Bureau of Planning and Sustainability

## MEMO

**SUBJECT:** 2035 Comprehensive Plan Early Implementation  
Minor/Technical Amendments

**Figure 130-9**  
**Façade Articulation**

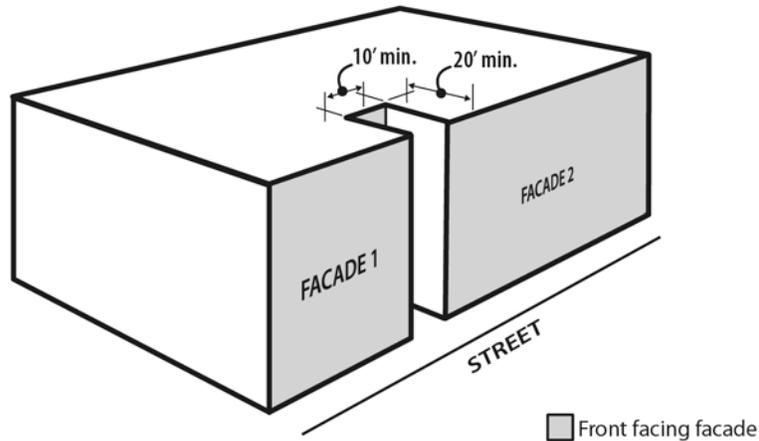
Amendment #2m: Add a new drawing (Figure 130-9) to better illustrate the façade articulation standards in 33.130.222 (pg. 153). Renumber the existing 130-9 through 130-17 to be 130-10 through 130-18.

**Figure 130-11**  
**Ground Floor Window Options for Dwelling Units**

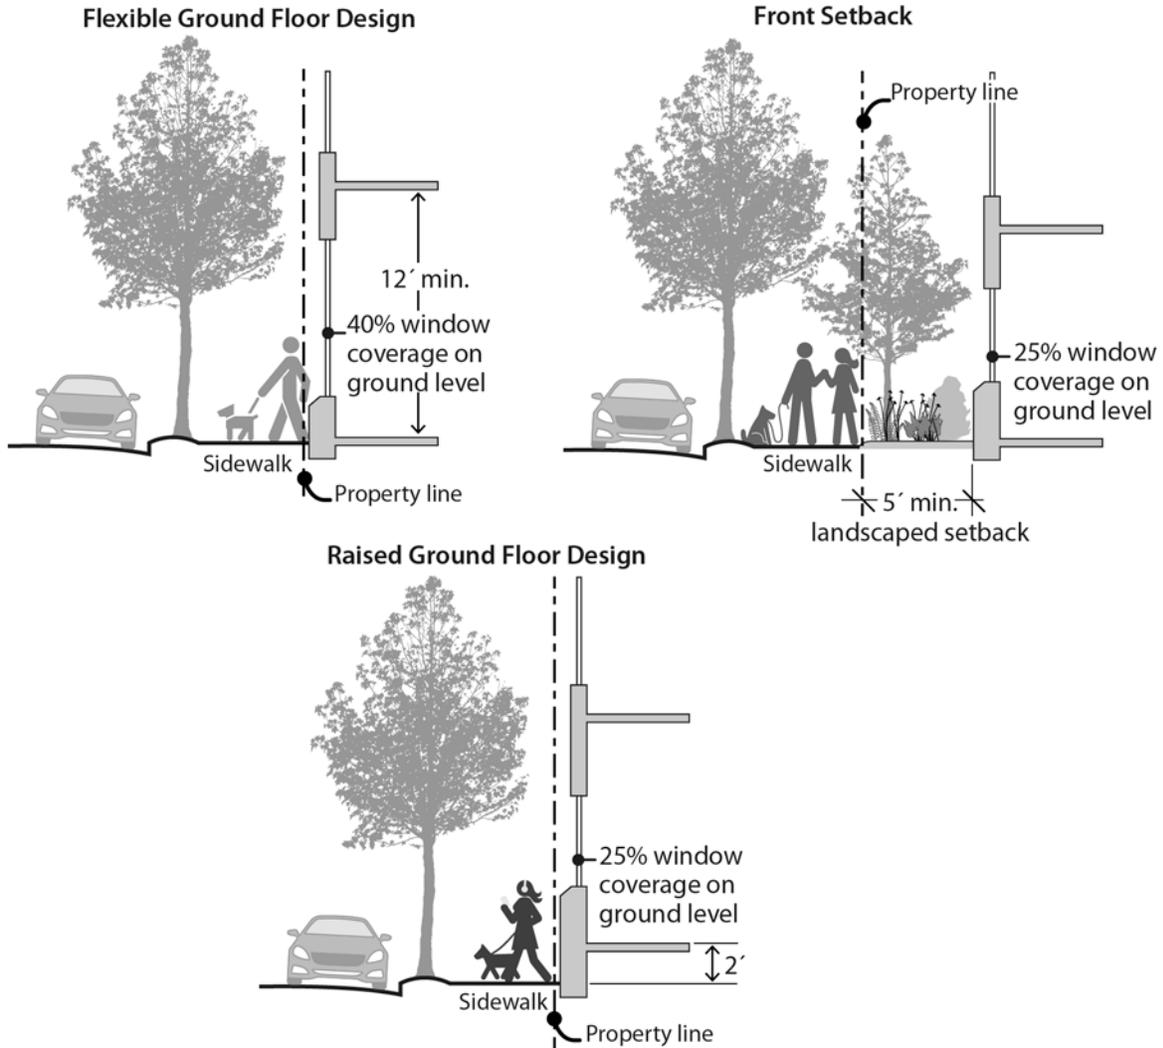
Amendment #2o: Fix figure 130-11(pg. 165) to show the property line in the right place
